REMARKS/ARGUMENTS

The Office Action dated January 26, 2004, has been carefully considered.

FIG. 7

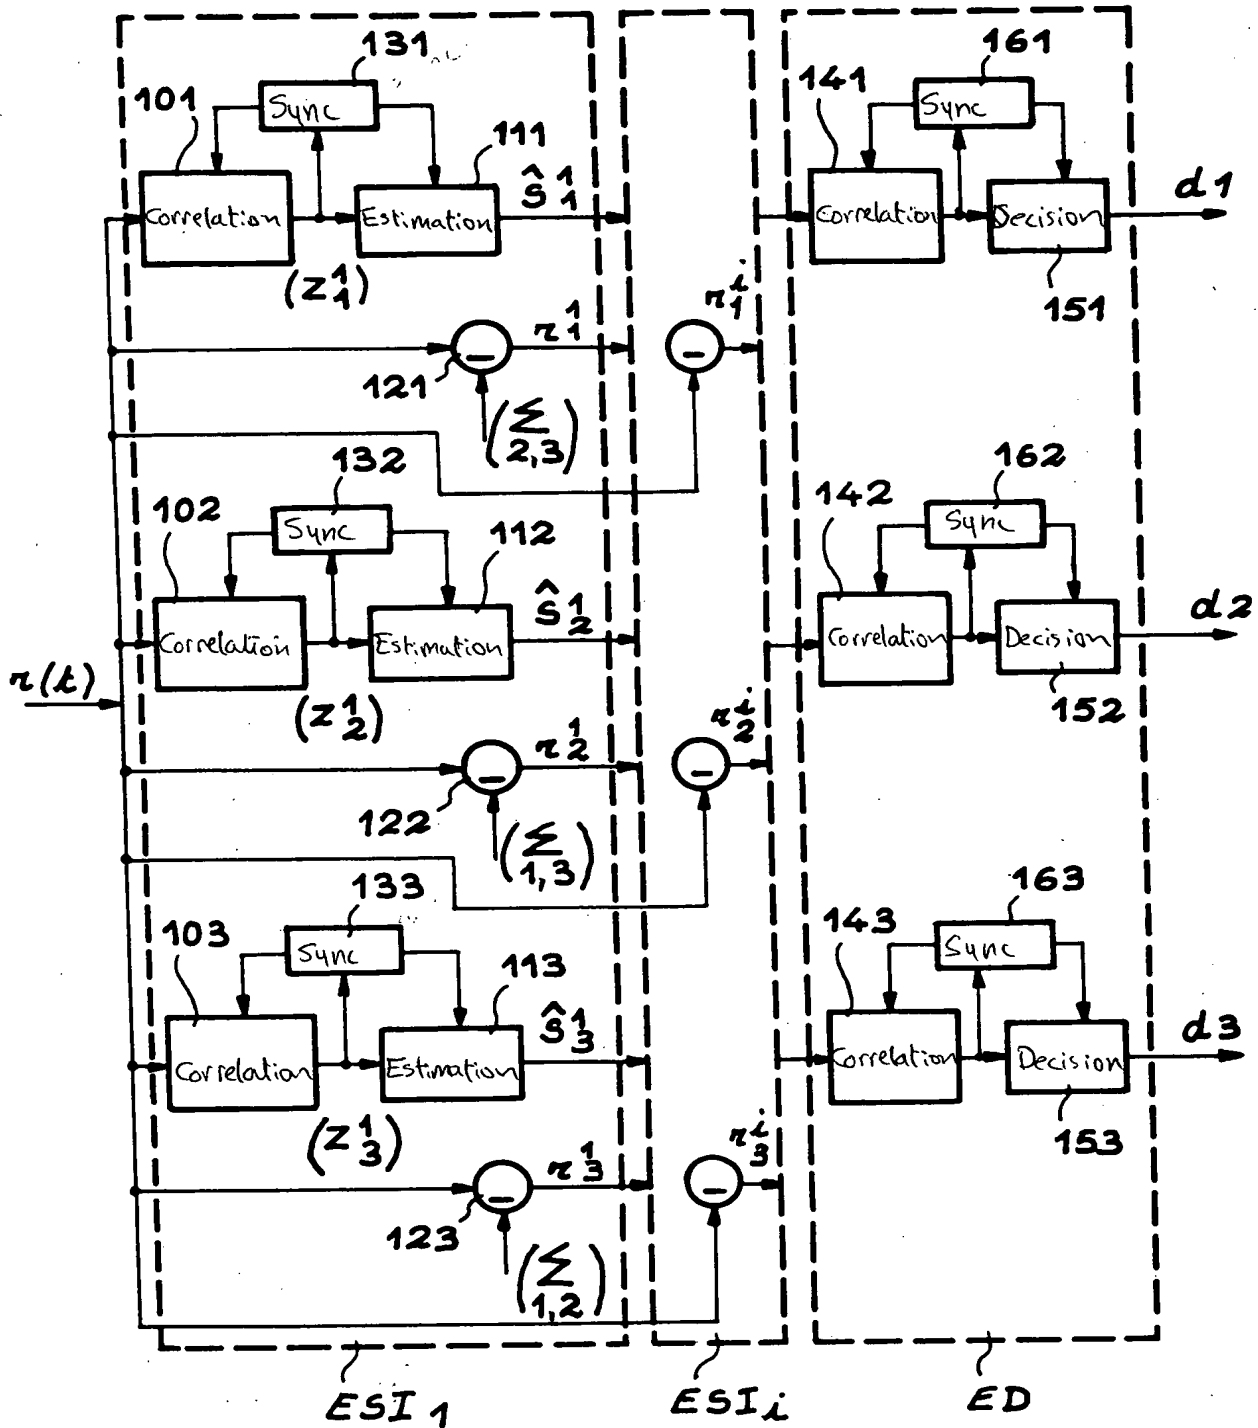
FIGS. 6 and 7 have been corrected to include reference numerals 121, 122, and 123, which were inadvertently omitted from the corrections previously submitted. Also, the descriptive legends in these drawings have been reinstated.

FIG. 8

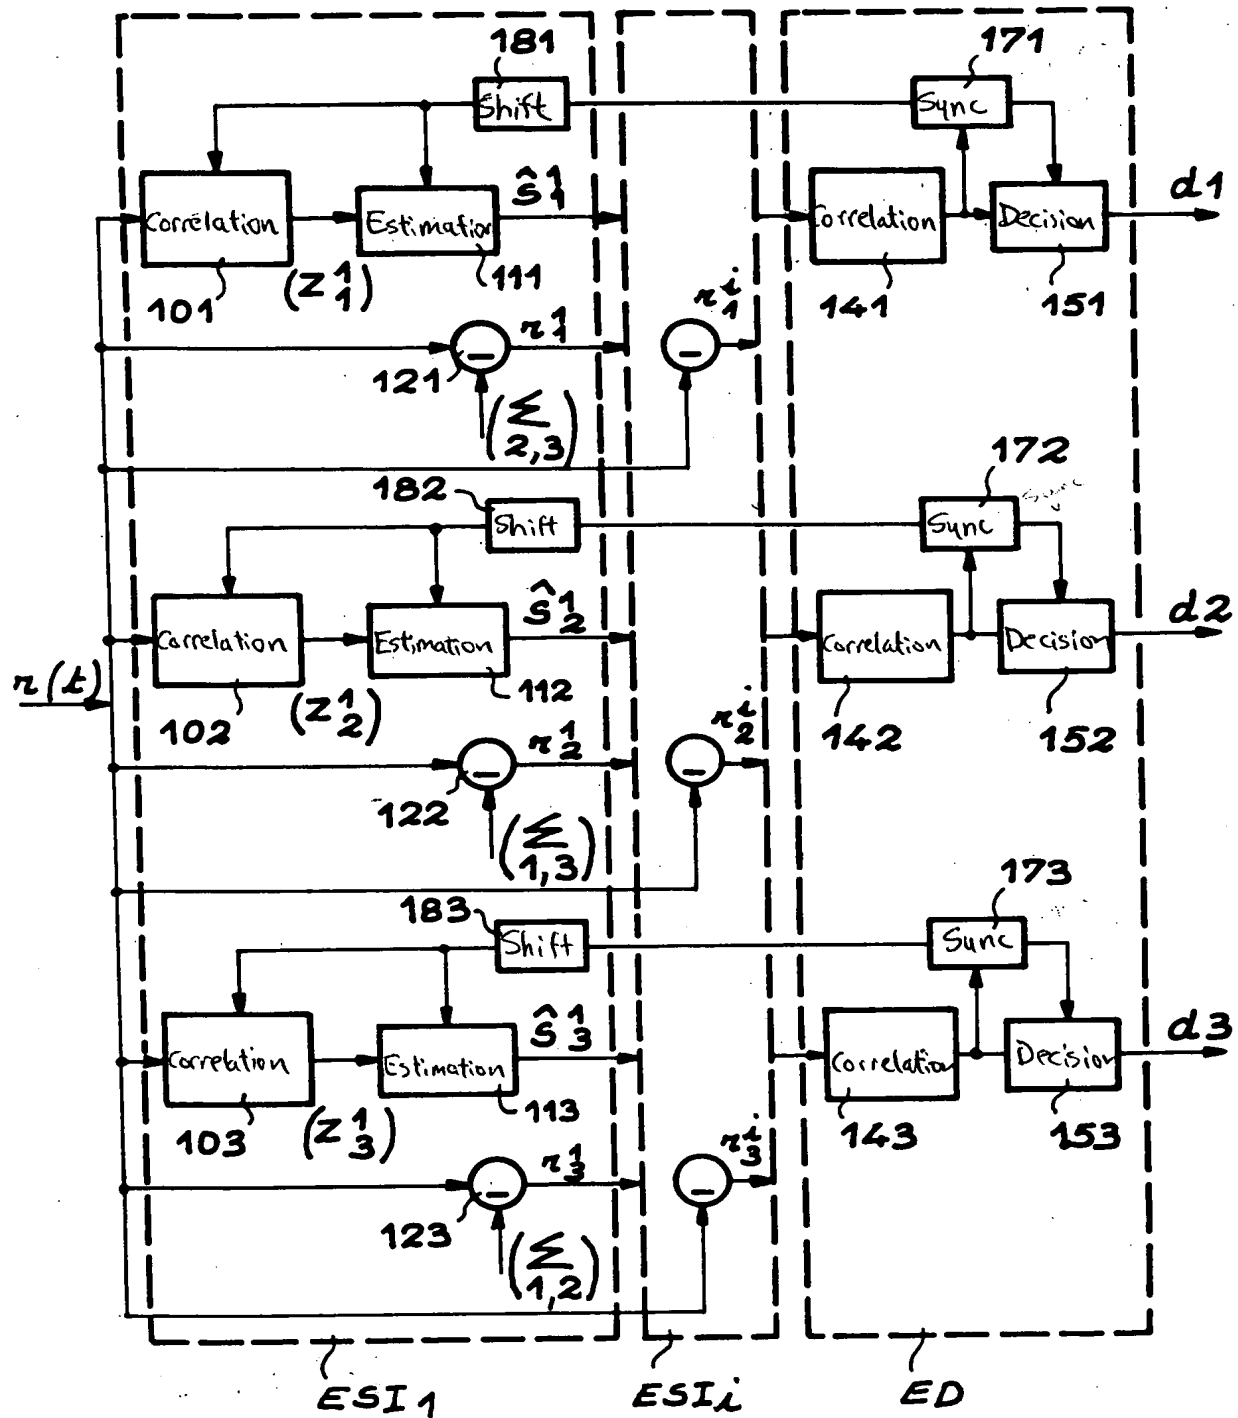
constituted by K means solely placed in the K channels of the final stage (ED),” (FIG. 8 depicts the means 171, 172, 172 for producing the synchronization signals within the broken-line box labeled ED), and that “the K synchronization signals produced by said K means [control] the K decision means of the K channels of the final stage (ED) and the interference estimation means of the K channels of the at least one interference suppression stages (ESI_i) following appropriate time shifts.” The K decision means are means 151, 152, 153, described as such for example on page 7, line 33 (again it is noted that that FIGS. 7 and 8 share some elements in common, as is commonly practiced). The interference estimation means of the K channels of the at least one interference suppression stages correspond to boxes 111, 112 and 113, described as such on page 11, line 17, for example. Time shifts are provided by circuits 181, 182 and 183. These relationships are clearly depicted in FIG. 8, showing appropriate arrows emanating from box 171 and pointing to box 151 in the final stage ED, and further pointing, by way of box 181, to box 111 in interference suppression stage box ESI₁. Based on the foregoing, it is urged that Claims 1-3 are in compliance with the enablement requirements, and withdrawal of 35 U.S.C. 112, first paragraph rejection is respectfully requested.
